Access Compliance Report Public Rights-of-Way (Curb Ramps)

Main Street: BRITTANY_WOODS_DR	Cross Street: BLUEBERRY_WAY	Location:	SE
--------------------------------	-----------------------------	-----------	----

ADA ID: RPAT211008150134	Ramp Type: Type 4 - Parallel	Initial Pass/Fail: Fail	Overall Compliance: No	Severity Score:	2
--------------------------	------------------------------	-------------------------	------------------------	-----------------	---

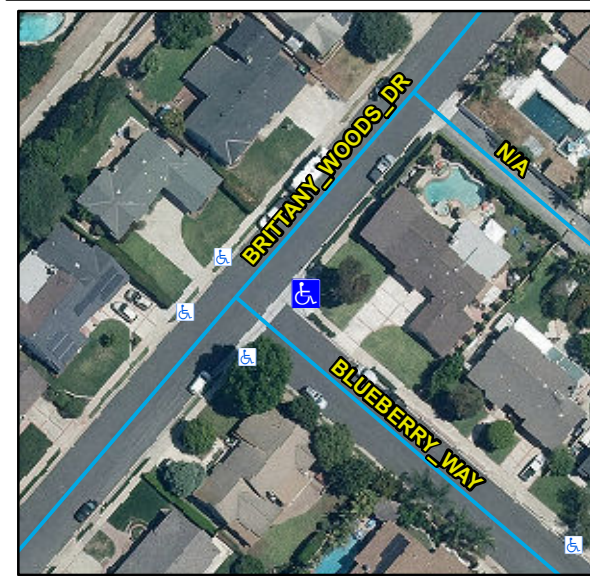
Compliance	Description	Data	Compliance	Description	Data
N/A	Ramp Length LT (in)	92	N/A	Ramp Length RT (in)	108
Yes	Ramp Width LT (in)	71	Yes	Ramp Width RT (in)	69
Yes	Ramp Run Slope LT (%)	7.3	Yes	Ramp Run Slope RT (%)	6.4
No	Ramp Cross Slope LT (%)	2.5	No	Ramp Cross Slope RT (%)	2.9
N/A	Landing Present	N/A	N/A	DWS Provided	N/A
N/A	Landing Length (in)	N/A	N/A	DWS Contrast	N/A
N/A	Landing Width (in)	N/A	N/A	DWS Length (in)	N/A
N/A	Landing Run Slope (%)	N/A	N/A	DWS Full Width	N/A
N/A	Landing Cross Slope (%)	N/A		DWS Offset Type	N/A
N/A	Landing Movement Obstructed?	N/A	N/A	DWS Offset Left (in)	N/A
	Landing Movement Type	N/A	N/A	DWS Offset Right (in)	N/A
N/A	Landing Shared	N/A			
N/A	Clear Space	Yes			
N/A	Clear Space To Crosswalk (in)	N/A			
N/A	Marked Crosswalk 1	No	N/A	Marked Crosswalk 2	No
	Crossing 1 Direction	N		Crossing 2 Direction	W
N/A	Marked Crosswalk 1 Width (in)	N/A		Marked Crosswalk 2 Width (in)	N/A

Remove & Replace Curb Ramp With Two New Directional Ramps or Equivalent.

R304.5.3, STD 1115
